North Campus Faculty Housing Phase II
Project No. FM110407L/986315
Addendum No. 5

September 22, 2011

ADDENDUM NUMBER 5
to the
CONSTRUCTION DOCUMENTS

SKETCH 3 OF 3
ADDENDUM 5

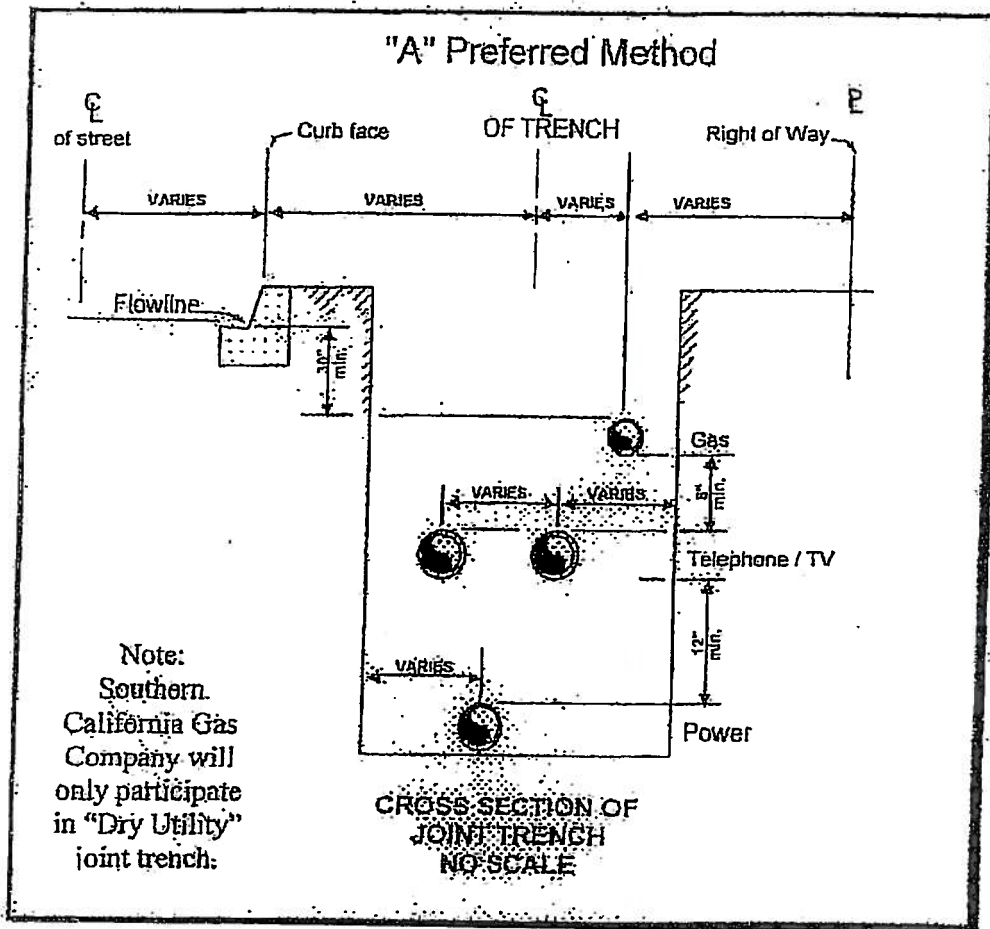
1. Dry Utility Plans Sheet 15, Phone, Cable, Gas Specifications: **Delete** in its entirety.
Add the attached Dry Utility Details and Notes Sketches 1-3, dated 8/1/11.
Sketch 1 of 3, Verizon Contractor Notes
Sketch 2 of 3, Cox Communications Contractor Notes
Sketch 3 of 3, The Gas Company Construction Notes – Trench Details

Note: For UCSB Project FM110407L/986315; Contractor provides trenching and backfilling, to Gas Co. standards, and Gas Company provides and installs its gas lines and meters.

E010-1

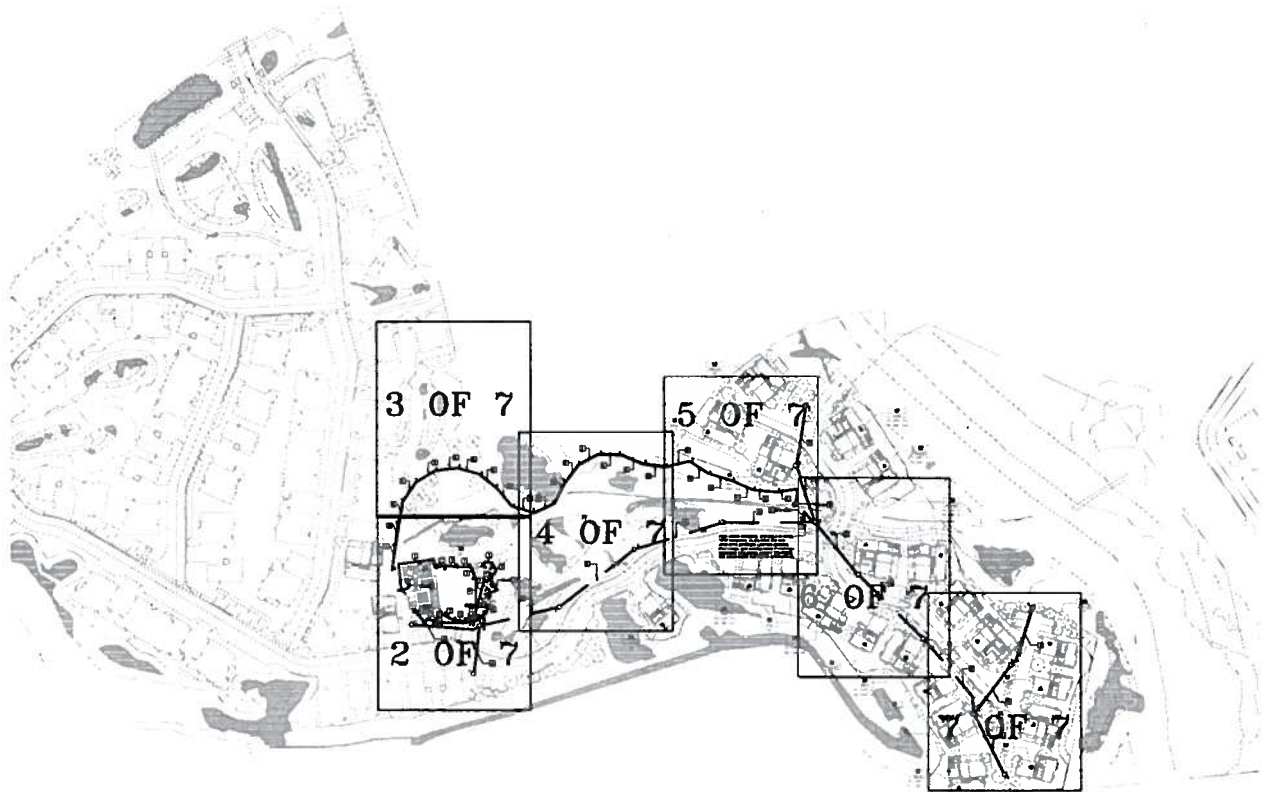
5. Sheet E010, Electrical Site Plan: **Add** the attached Electrical Sketches E010-1 thru E010-7, dated 9/20/11.
Sketch E010-1 Electrical Site Plan Sheet E010
Sketch E010-2 Electrical Site Plan Sheet E010
Sketch E010-1 Electrical Site Plan Sheet E010
Sketch E010-1 Electrical Site Plan Sheet E010
Sketch E010-1 Electrical Site Plan Sheet E010
Sketch E010-1 Electrical Site Plan Sheet E010
Sketch E010-1 Electrical Site Plan Sheet E010

TITLE : Addendum 5
 Precise Grading Plan (Sht 8)
 UCSB North Campus Faculty Housing - Phase II
 University of California, Santa Barbara
 Santa Barbara, California

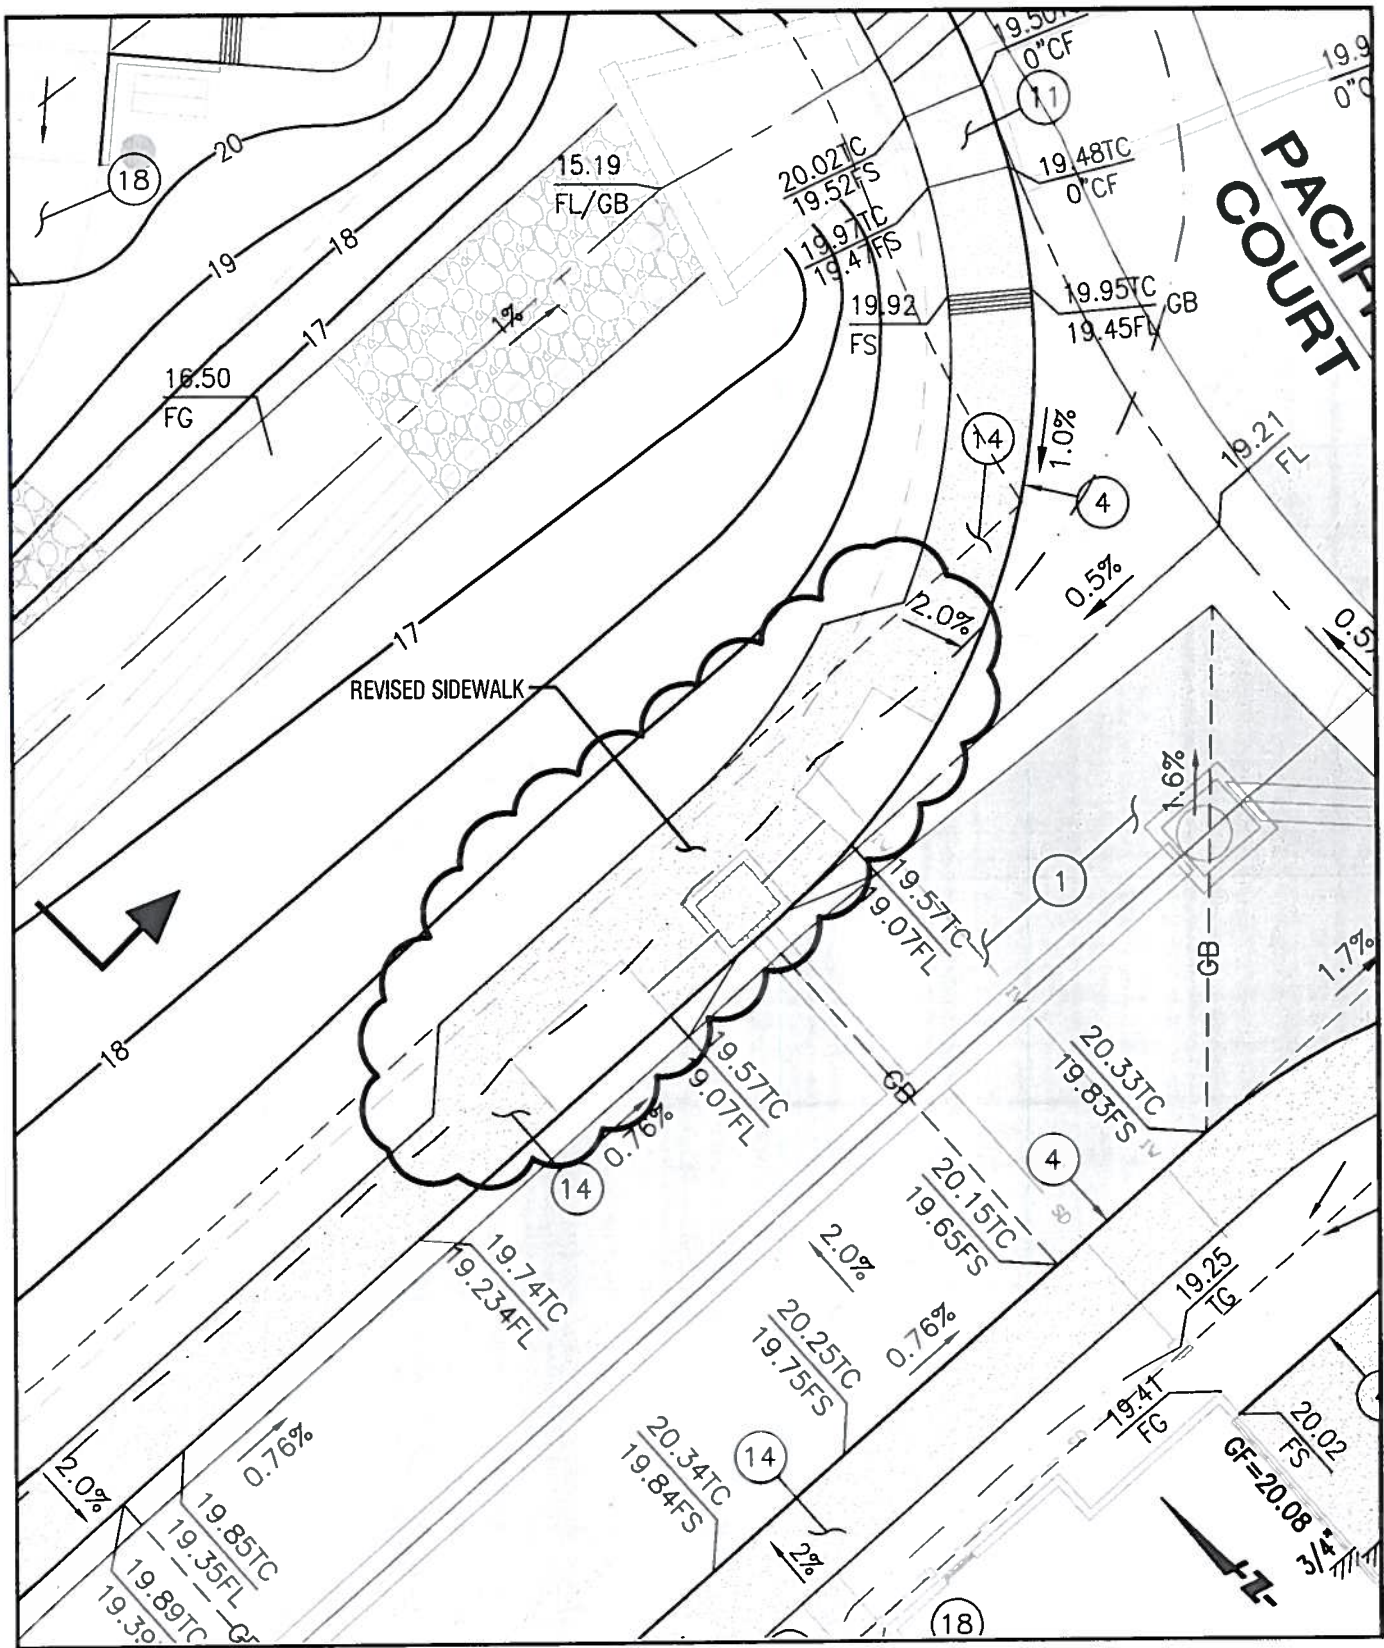
1. Add the attached Precise Grading Plan Sketches 1-3, dated 9/21/11,
Sketch 1 of 3 Addendum 5, Precise Grading Plan (Sheet 8)
Sketch 2 of 3 Addendum 5, Precise Grading Plan (Sheet 9)
Sketch 3 of 3 Addendum 5, Precise Grading Plan (Sheet 10)
